# Appendix A

LB Camden comments

**From:** Dewes, Tatai <Tatai.Dewes@camden.gov.uk>  
**Sent:** 05 November 2019 12:21  
**To:** Alex Neal <ANeal@geraldeve.com>; Henry, Kate <Kate.Henry@camden.gov.uk>  
**Cc:** Sam Avis <SAvis@geraldeve.com>  
**Subject:** SPCC - transport comments

<b>To:</b>	Kate Henry
<b>From:</b>	Tatai Dewes
<b>Date:</b>	7 <sup>th</sup> November 2019
<b>Re:</b>	St Pancras Commercial Centre 63 Pratt Street London NW1 0BY
<b>Proposal:</b>	Demolition of existing buildings (Class B1c/B8); erection of 3x buildings ranging in height from 5 to 7 storeys above ground and a single basement level comprising a mixed use development of light industrial floorspace (Class B1c/B8), office floorspace (Class B1), 33x self-contained dwellings (Class C3), flexible retail floorspace (Class A1/A3); associated access and servicing, public realm, landscaping, vehicular and cycle parking, bin storage and other ancillary and associated works
<b>Reference:</b>	2019/4201/P
<b>Key points:</b>	Recommended for approval subject to

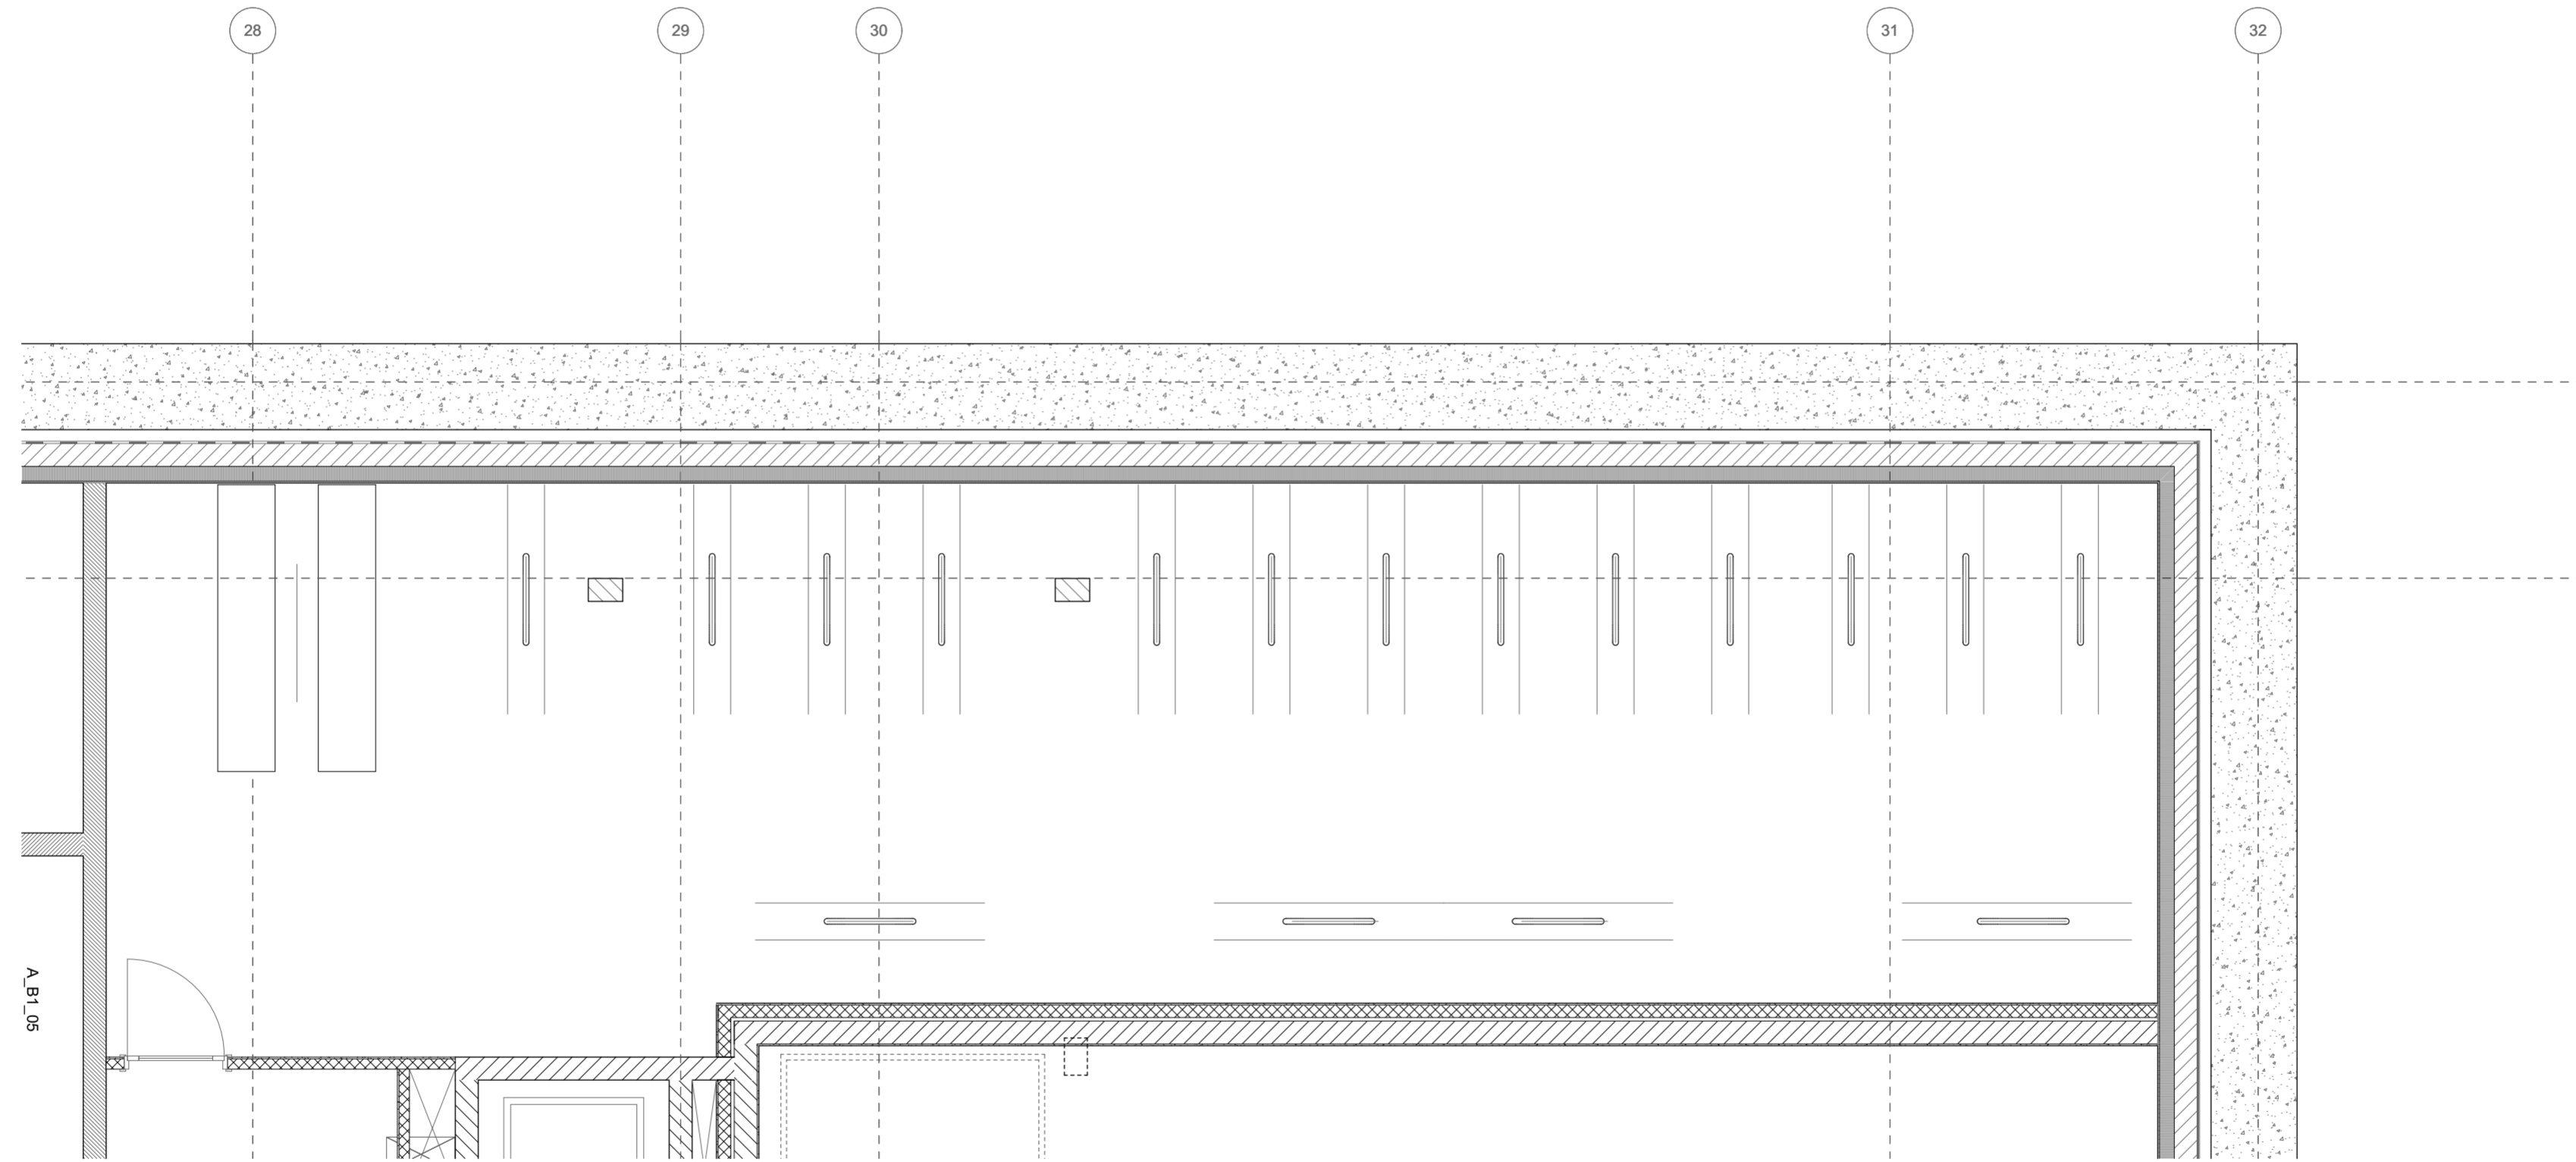
2. A plan is required to show how the gates function that open onto the Pratt Street end of the service street, to confirm they do not open outwards onto the footway/public highway.
3. Relocation of vehicle entrance on Pratt Street requires the relocation of a tree and a build out in the footway on the north side of Pratt Street to accommodate the tree. This build out is not acceptable as the proposed remaining carriageway width is not sufficient to accommodate the new proposals.

SKETCH - Basement Affordable Plan Cycle Store

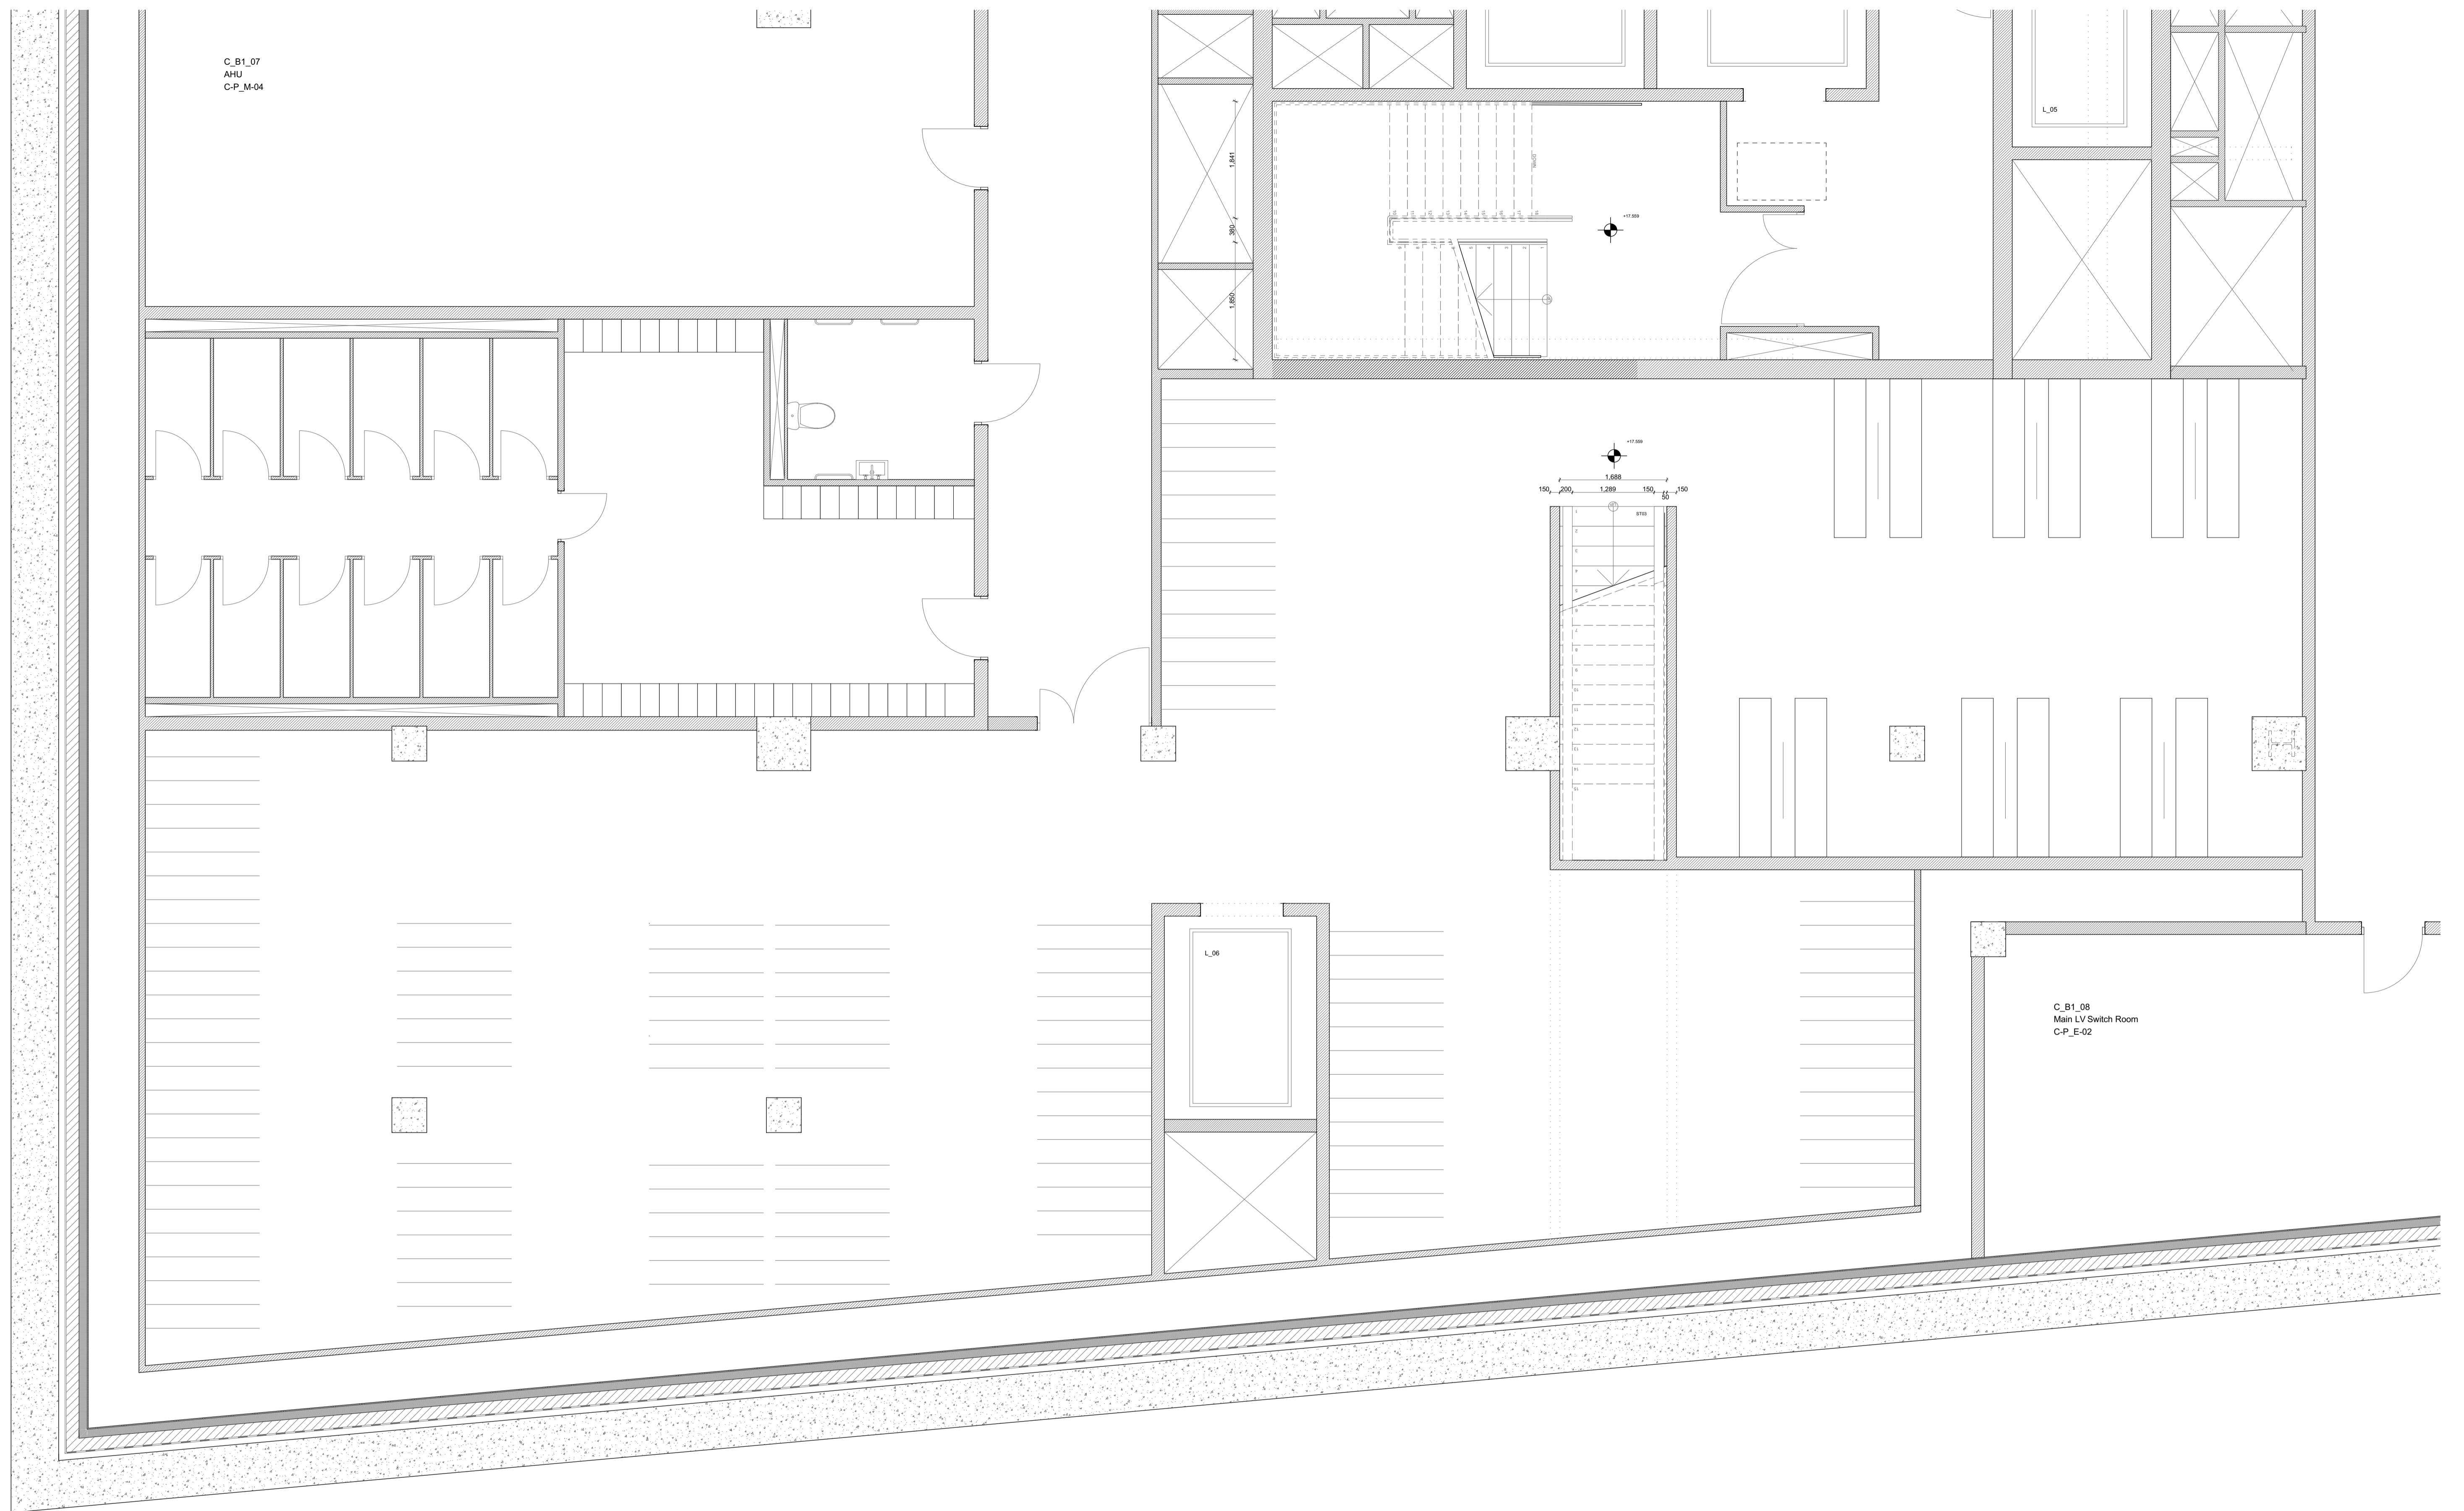
1. Further information and detailed plans are required for the cycle parking, detailed below:
  - a. The level of provision proposed does not meet the minimum requirement of the draft London Plan for residential and retail uses. The proposed provision falls two short of the residential requirement (currently at 59). The shortfall in residential spaces may be due to the revised plans increasing the number of residential units from 32 to 33. The extra spaces need to be accommodated, as are the retail spaces.

- b. There are no retail spaces provided. These need to be provided and detailed in the plans.
  - c. The council also expects that there is a provision for non-standard cycles. The Transport Assessment confirms that 5% of spaces in the office cycle store will be configured to accommodate non-standard cycle designs including those for users with mobility impairments. These spaces should be outlined in the detailed plans.

- d. The 15 spaces required as part of the Light Industrial use are proposed to be either located in with the B1 office cycle store or within the Light Industrial units themselves. The cycle provision for the different uses needs to be separate, as these uses/buildings will be under separate use and management. The location of the spaces needs to be shown on the plans.

- e. More information is required on the type of stands and the detailed design/layout of the cycle parking stores to assess if the design meets the requirements set out in CPG Transport and TfL's cycle parking guidance (LCDS). These plans need to be to scale, and include the distance between each stand, the widths of isles between stands and between stands and walls. The dimensions of the lifts (door and lift width, length) should also be given or shown on the plans.
